## Brisbane Central Business District Bicycle User Group

I write to you on behalf of Brisbane CBD BUG members regarding our concerns that Brisbane City Council officers are providing instructions to property developers in the design of active transport infrastructure that conflict with Queensland Transport and Main Roads (TMR) Guidelines and Austroads Guidelines.

This issue came to light recently when the CBD BUG was reviewing past development applications, we viewed A004206778 for 17 Skyring Tce, Newstead of 2016. We have to say what was proposed for the active transport corridor along the river was in line with TMR and AustRoads guidelines. The corridor was segregated between user groups, the respective path widths were of appropriate dimensions and the bends were gentle in nature. However, a Brisbane City Council officer has clearly marked on the submitted drawing "riverwalk to be provided as a 6m shared pathway" (figure 1). This instruction contradicts relevant traffic engineering guidelines as we will explain below.

Figure 1 - Landscaping sheet 3239-01 (Rev-C)

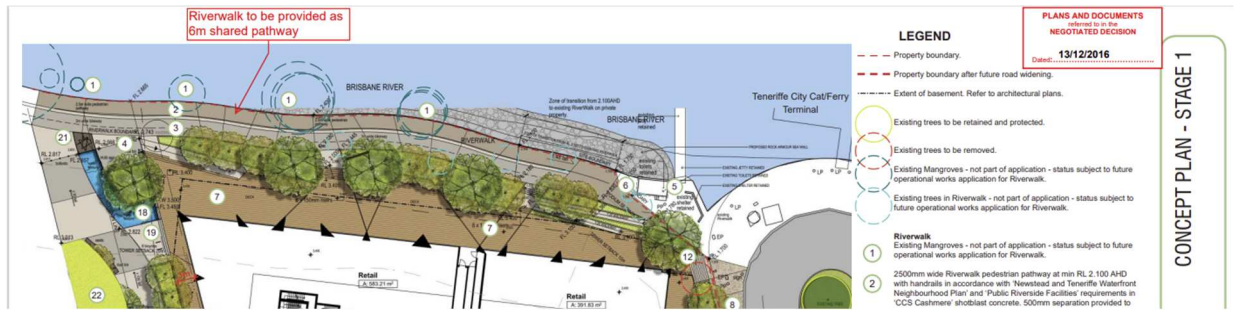
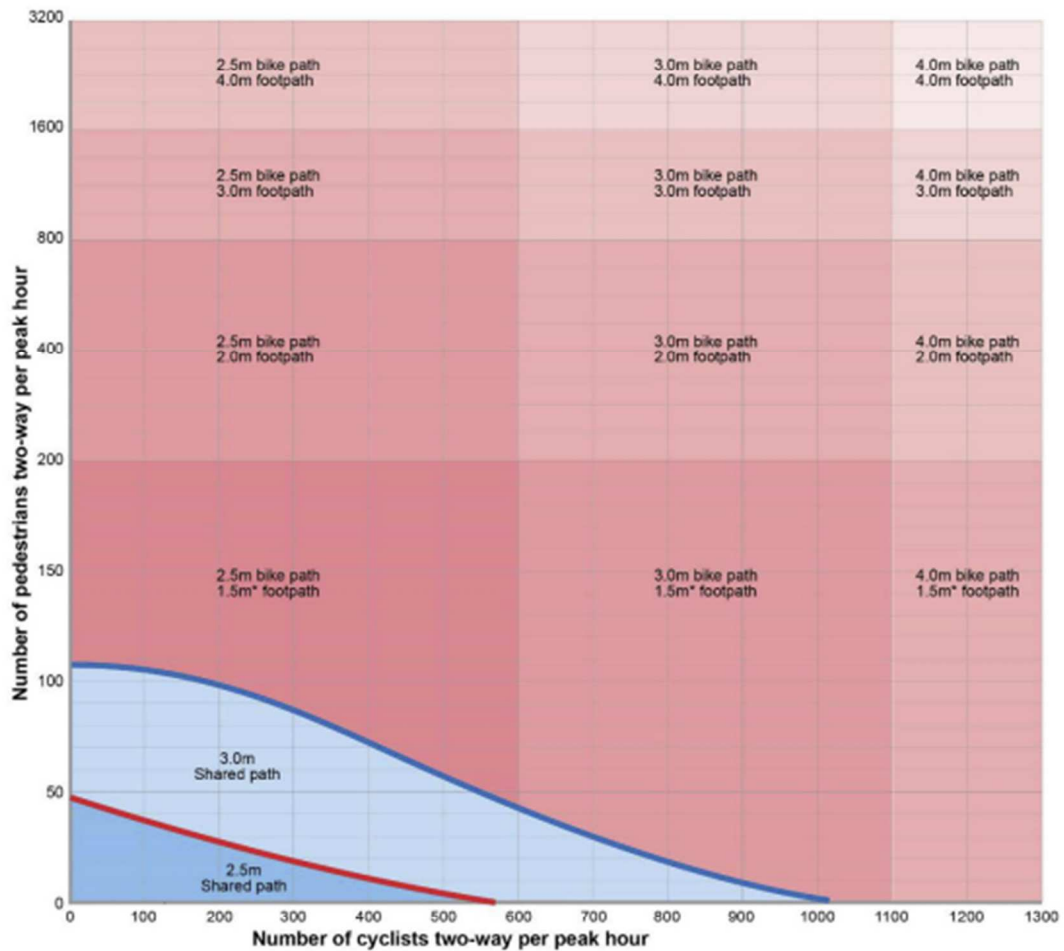
As can be seen from the above, the instruction that the Brisbane City planner gave to the development applicant is a contradiction of relevant traffic engineering guidelines. The fact is past development applications guide future development applications and past instructions will be often referenced when designs are being negotiated with council.

1. remain cognisant of the active transport guidelines cited earlier in this letter, and
2. ensure these guidelines are applied in assessing development applications to ensure active transport infrastructure is installed that is appropriate to the community's needs.

Figure 2 – TMR guideline – Supplement to AustRoads Guide to Road Design, Part 6A: Pedestrian and Cyclist Path

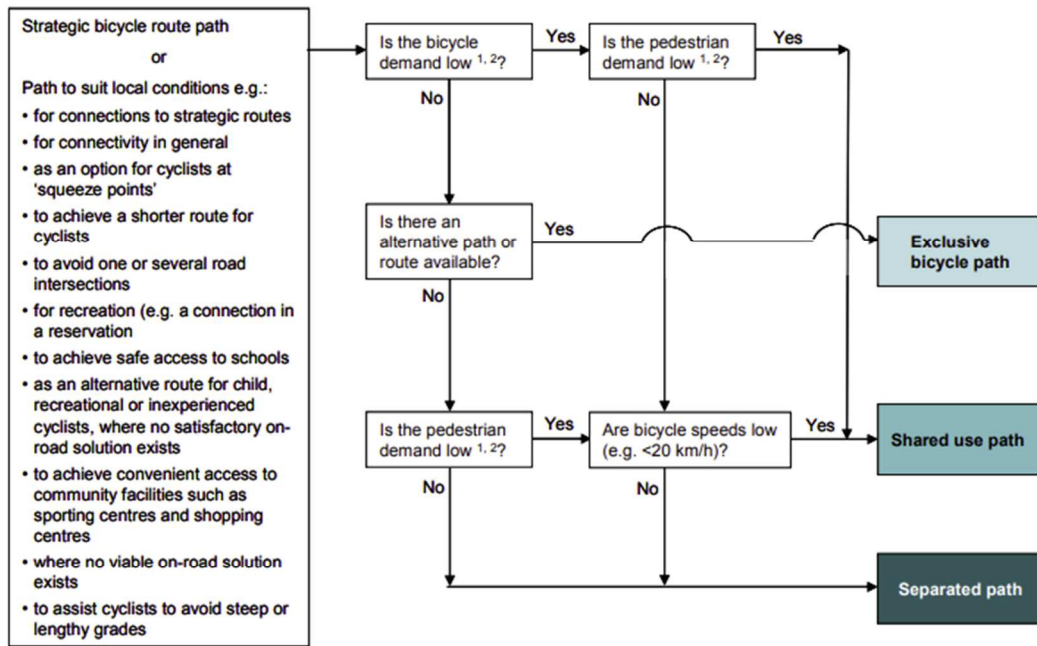
As can be seen, this engineering guideline was released a full year before council gave its instruction. Recently the CBD BUG conducted an on-location patronage count for another development on the site in question and the result of the count overwhelming indicated that a shared path was not in line with the TMR guidelines. Even allowing for 30% reduction in patronage along the corridor (to account for years past), Figure 6a-3 of the guide (figure 2) clearly shows once again a shared path as instructed by BCC is not in compliance with the traffic engineering.

Figure 4 - Brisbane City Plan 2014 - Bicycle overlay

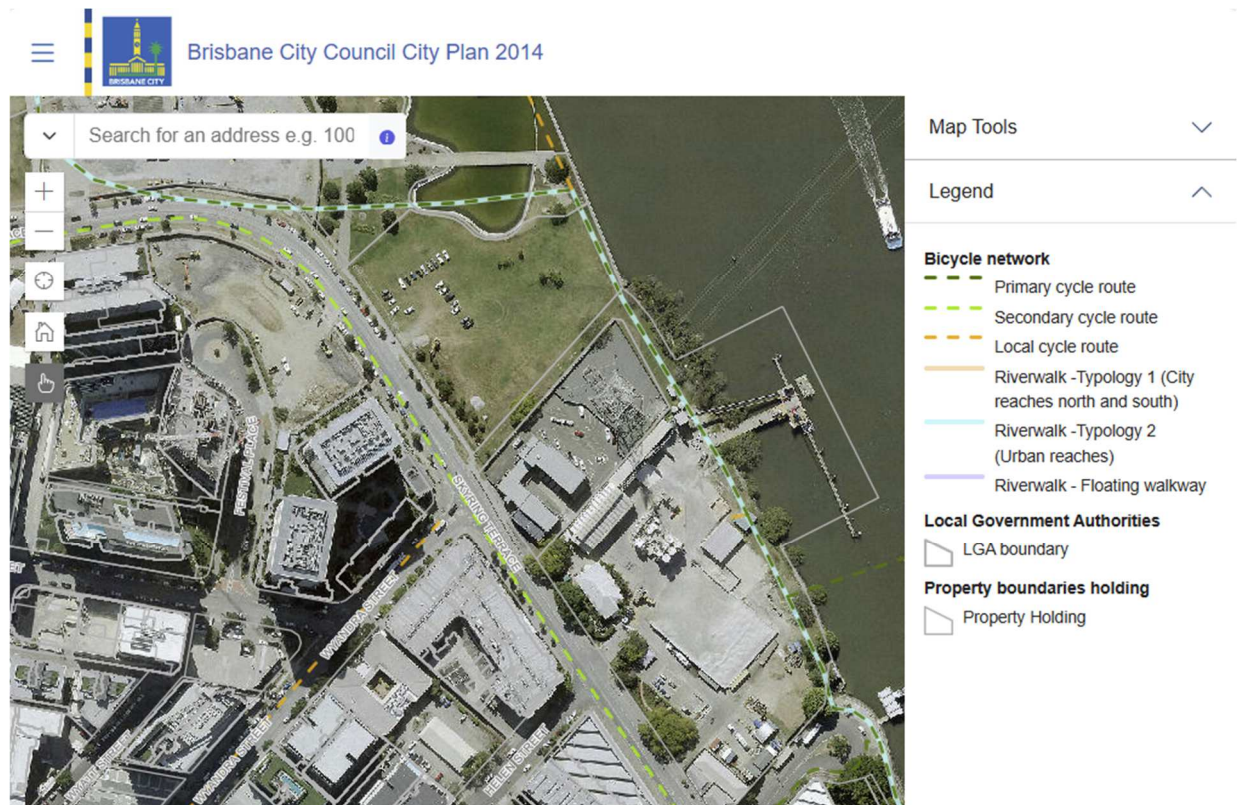
The advice from this engineering guide is even clearer. The flow graphic (figure 3) makes the type of path recommended very clear. By Brisbane City Plan 2014 (figure 4) designating the corridor as "primary" Brisbane City Council has acknowledged there will be a high number of cycle movements, and it is a well known fact that riverside paths experience high pedestrian patronage. Both these points in combination with it being a commuter corridor clearly indicate that the most suitable engineering solution is to segregate path user groups.
